Resolution of the ongoing discussion on use of MMSE tap-weight optimization for TDECQ

Relative to Comments I-28 (Ghiasi), I-37 (Le Cheminant) against draft 3.0 802.3db

IEEE P802.3db 100 Gb/s, 200 Gb/s, and 400 Gb/s Short Reach Fiber Task Force

TF Ad Hoc Teleconference, April 28, 2022

Correlation of Full Grid Search and MMSE-based tap weight optimization

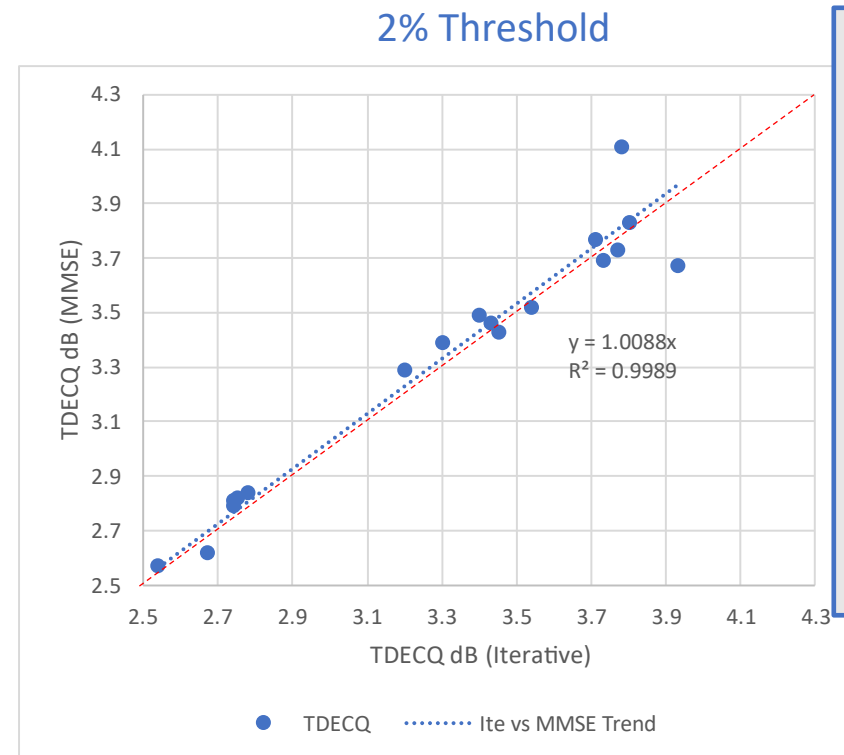
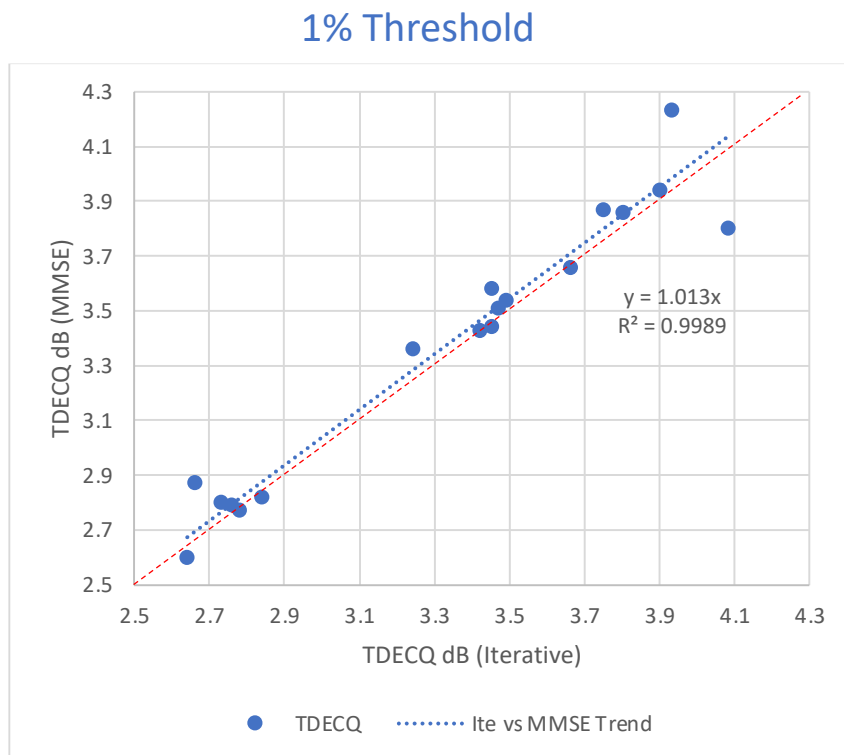
- Result from [ghiasi 802.3db 01 092321](#)
 - For 2% threshold that was adopted the MMSE vs full grid search has an $R^2=0.9989$!

Note fitted trendline (blue) slightly above ideal 1:1 (red).

MMSE values should be greater than or equal to Full Search values for the same waveform. (Measurement uncertainty/repeatability can result in MMSE reporting slightly lower values)
